Proposal for amendments to Regulation No. [xxx] (the Moving Off Information System for the Detection of Pedestrians and Cyclists)

The text was reproduced below was prepared by the experts from the VRU-Proxi Informal Working Group (VRU-Proxi) to amend the new UN Regulation on uniform provisions concerning the approval of motor vehicles with regard to the Moving Off Information System for the Detection of Pedestrians and Cyclists. The modifications to the existing text of the draft Regulation (see GRSG-118-06) are marked in bold for new or strikethrough for deleted characters.

Informal document No. **GRSG-119-xx**
 (119th GRSG, 06-09 October 2020
 agenda item xx)

Figure 1
 Set Up for Static Crossing Tests

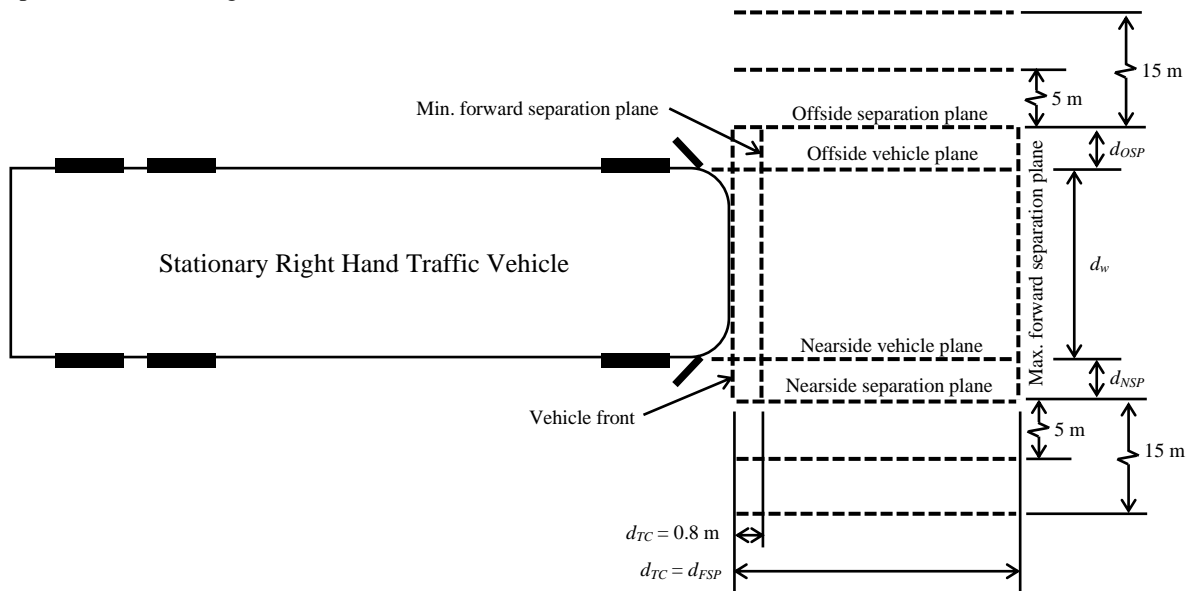
- d_w vehicle width.
- ~~$d_{25\%}$ a distance relating to 25% of the vehicle width.~~
- d_{NSP} the distance from the nearside vehicle plane to the nearside separation plane, defined as 0.5 m.
- d_{OSP} the distance from the offside vehicle plane to the offside separation plane, defined as 0.5 m.
- d_{TC} the forward separation distance for each test case.
- d_{FSP} the distance from the vehicle front to the maximum forward separation plane.
- ~~d_{LPI} the distance relating to the last point of information (LPI).~~

- d_{NSP} the distance from the nearside vehicle plane to the nearside separation plane, defined as **0.5 m.**
- d_{OSP} the distance from the offside vehicle plane to the offside separation plane, defined as **0.5 m.**
- d_{TC} the forward separation distance for each test case.
- d_{FSP} the distance from the vehicle front to the maximum forward separation plane.
- d_{LPI} the distance relating to the last point of information (LPI).

VRU-Proxi#15: FR, EU agree.

1. Justifications for paragraph 5.2.2.3.3.: MOIS focuses on straight driving situations. As the testing procedure is not defined, this part of the requirement may lead to too many testings.
2. Justifications for paragraphs 5.4.2 to 5.4.4: Paragraph numbers modified as 5.4.2. was used twice.
3. Justifications for paragraph 5.5.1.: In VRU-Proxi#14, we agreed to use the word initialisation instead of calibration to be in line with the wording used in the AEB regulation. The MOIS (and the AEB) needs driving situations to initialise the system.
4. Justifications for paragraph 5.7.4: As the testing procedure is not defined, this part of the requirement may lead to too many testings.
5. Justifications for paragraph 5.8.3.: 5.8 deals with failure warning signals.
6. Justifications for Appendix 1.: clarifications of the definitions listed for the table 1 and figure 1.
